NOTICE TO ALL FIRMS

Re: Addendum Number 3
IFB # C1556R – Kaufman Hall Access Controls

**F.I.T. STUDENT HOUSING CORP
KAUFMAN HALL ACCESS CONTROL
ALLEGION/SCHLAGE HARDWARE & INSTALLATION
INVITATION FOR BID NUMBER C1556R
NYS PREVAILING WAGE SCHEDULE PRC # 2022010668**

KAUFMAN - BASEMENT FLOOR

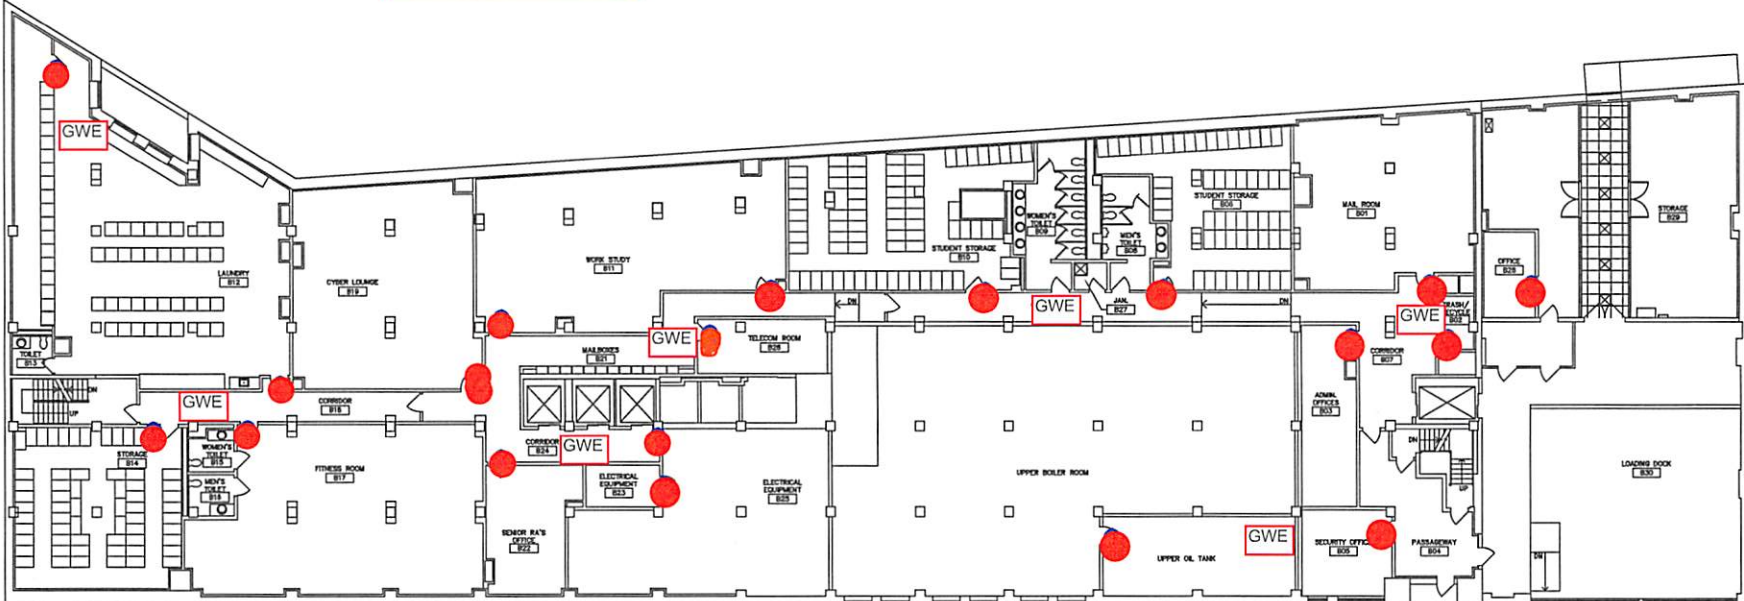
Q1. The amount of locks listed in the text box of the updated drawings in Addendum No. 2 still doesn't add up to what is shown in the drawings.

A1. Our apologies, we have recalculated the amount of locks that we need, updated the drawings and the amount listed in the text box (See updated drawings attached). The new lock and gateway amounts are:

0 x Unit Entry (LEBMD)
19 x Other lock (LEBMS) ●
7 x Schlage Gateways

KAUFMAN - 1ST FLOOR

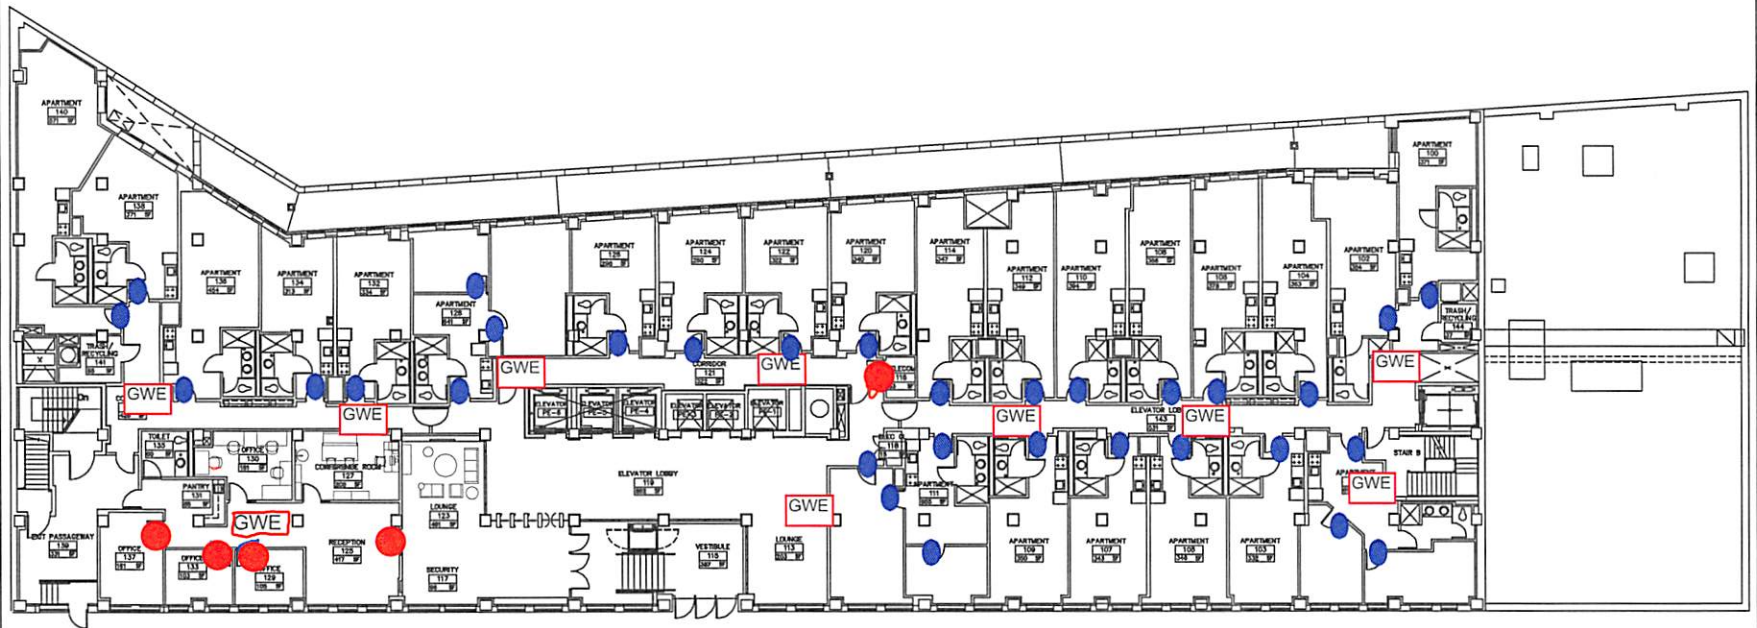
- Q11. Where are the IT closets located on the floors? During the walk through we were told they are at the end of the hallway on the west end of the building but the drawing shows something in the middle of the floor. We will need those locations for the CAT6 lengths for the cable runs.

- A11. The IT closets are in the middle of the floors, just West of the elevators, not at the end of the hallway. They are shown as the **Red dot** on the drawings. (See updated drawings attached)
